Intel® Mobile Pentium® III Processor Specification Update

Release Date: March 2000

Order Number: 245306-005

Figure 7. BCLK Timing Waveform

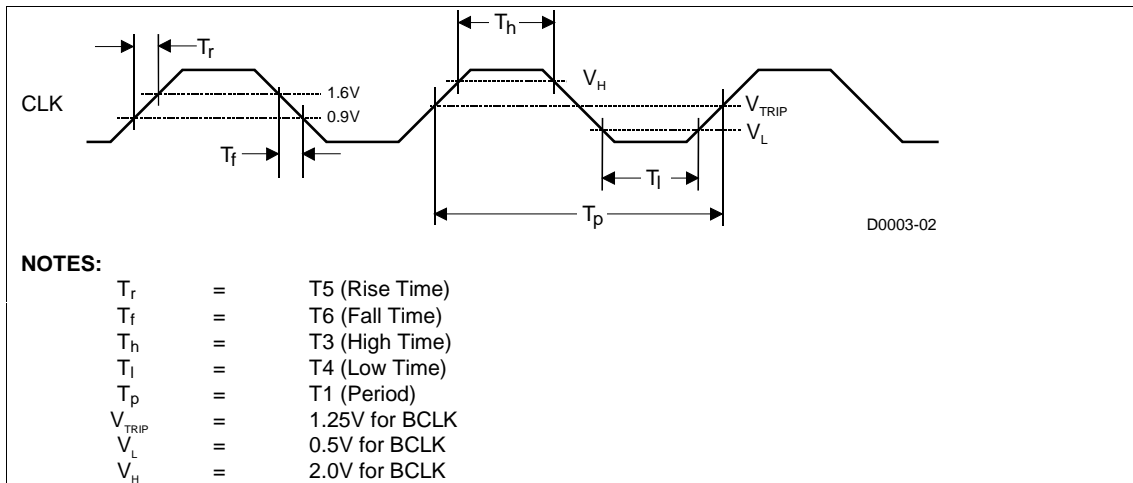
For B0 step processors, the $V_{IH,BCLK}$ Min spec is changed to 2.0V (from 1.7V for A2 step) and $V_{IL,BCLK}$ Max spec is changed to 0.5V (from 0.7V for A2 step). Due to this, new values are specified for BCLK high and low times for B0 step processors. These modifications affect corresponding specs in Table 13, Table 14, Table 24, and Figure 7 in *Mobile Pentium® III Processor in BGA2 and Micro-PGA2 Packages datasheet* (Order Number 245302-002).

Symbol	Parameter	Min	Typ	Max	Unit	Figure	Notes
	System Bus Frequency		100		MHz		
T1	BCLK Period		10		ns	Figure 7	Note 2
T2	BCLK Period Stability			± 250	ps		Notes 3, 4
T3	BCLK High Time	2.70			ns	Figure 7	at >2.0V
T4	BCLK Low Time	2.45			ns	Figure 7	at <0.5V
T5	BCLK Rise Time	0.175		0.875	ns	Figure 7	(0.9V – 1.6V)
T6	BCLK Fall Time	0.175		0.875	ns	Figure 7	(1.6V – 0.9V)
